ADDENDUM NO.: 5

DATE OF ADDENDUM: February 27, 2015

**NEW DINING FACILITY  
CENTRAL CONNECTICUT STATE UNIVERSITY  
NEW BRITAIN, CT  
CF-RC-382**

FOOD SERVICE DRAWINGS - FS0.3 AND FS1.3, AND SPECIFICATION SECTION 114000 - FOOD SERVICE EQUIPMENT

SK FS-08

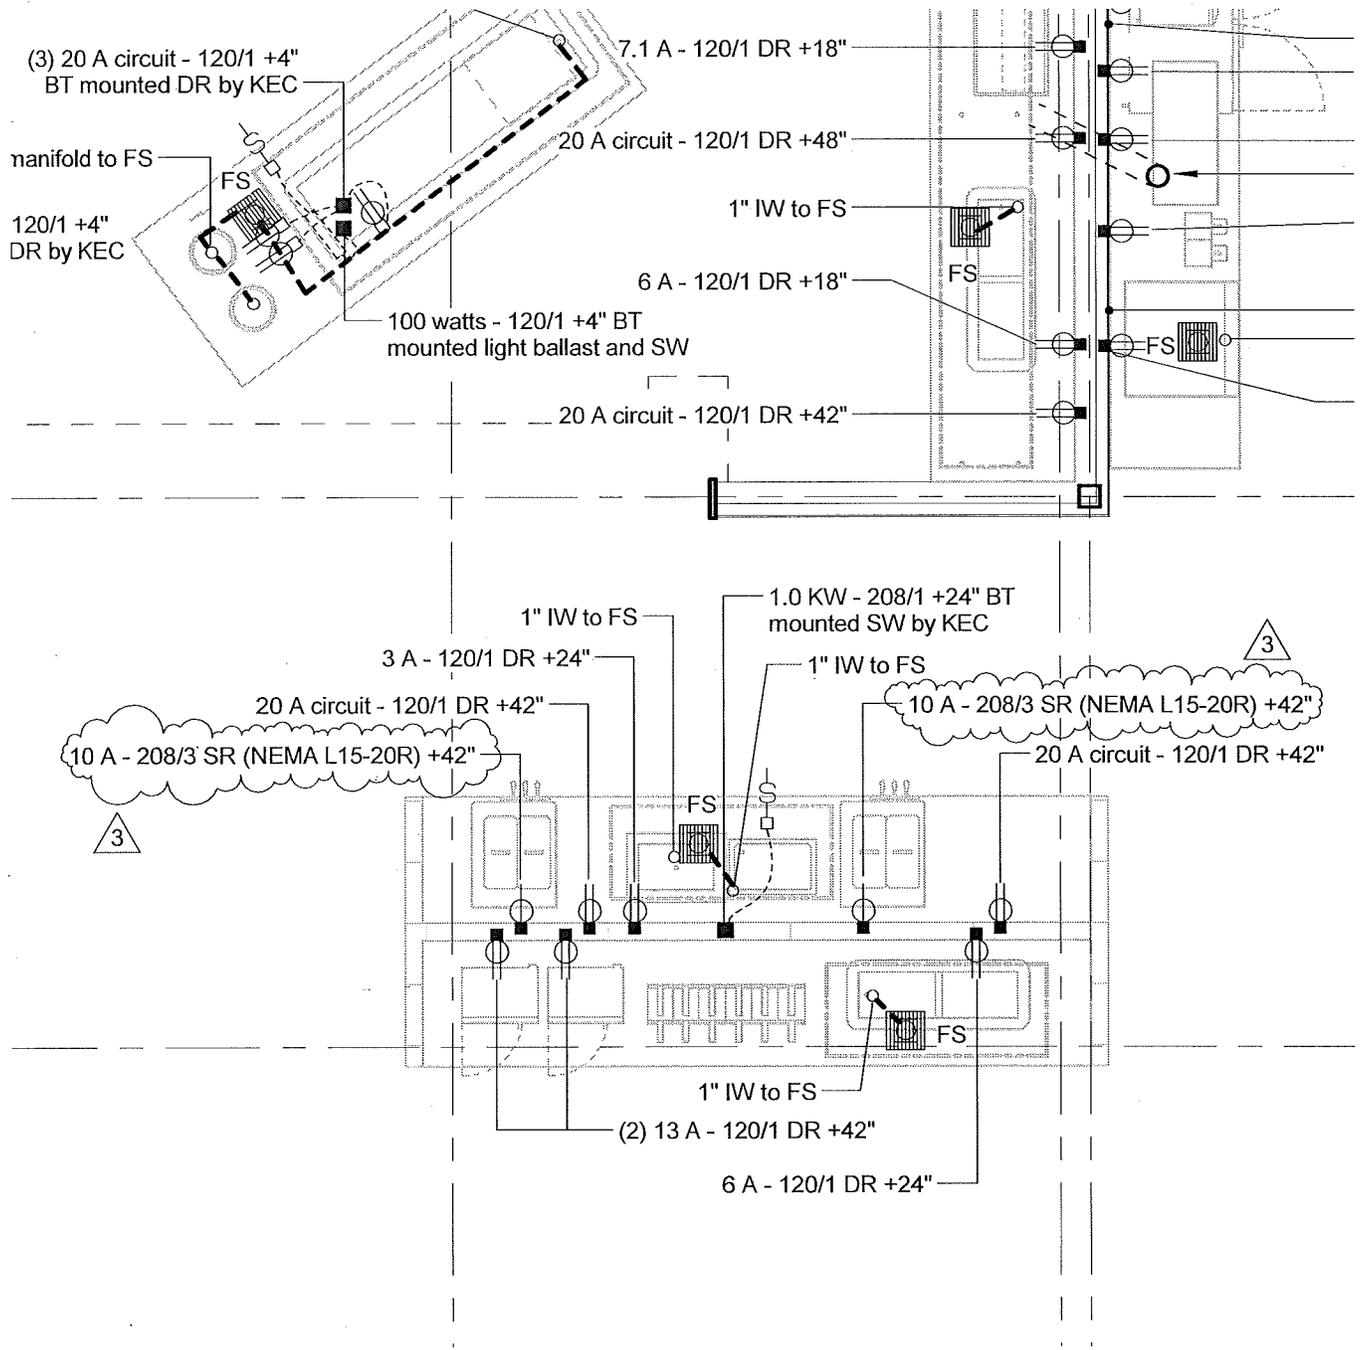
<u>Sheet</u>	<u>Description</u>
1.	FS0.3	Change electrical requirement for Item 194, Soft serve machines to 10 amps - 208/3 - C&P (NEMA L15-20P)
2.	FS1.3	Change electrical rough-in at Item 194, Soft serve machines to 10 amps - 208/3 - NEMA L15-20R +42"

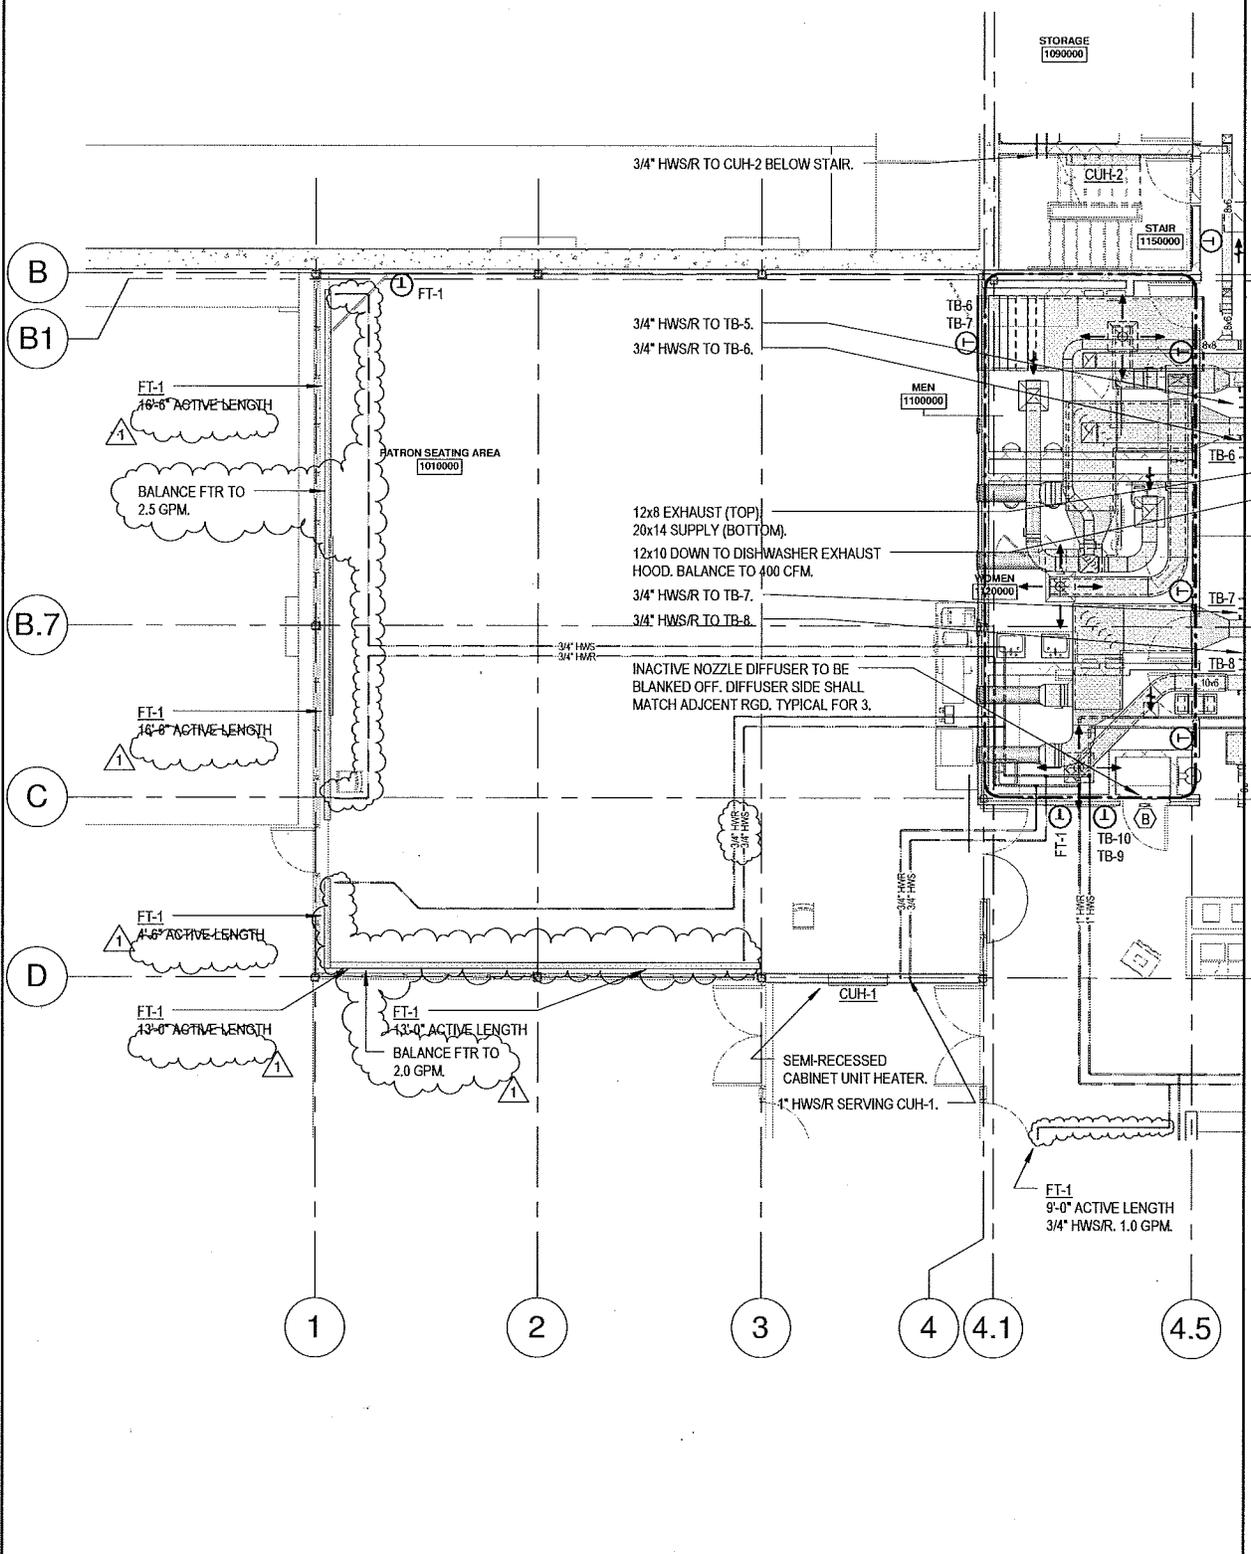
The attached sketch SKM-03 FIRST FLOOR PLAN MECHANICAL, dated 02/26/15, modifies Drawing M1.1.
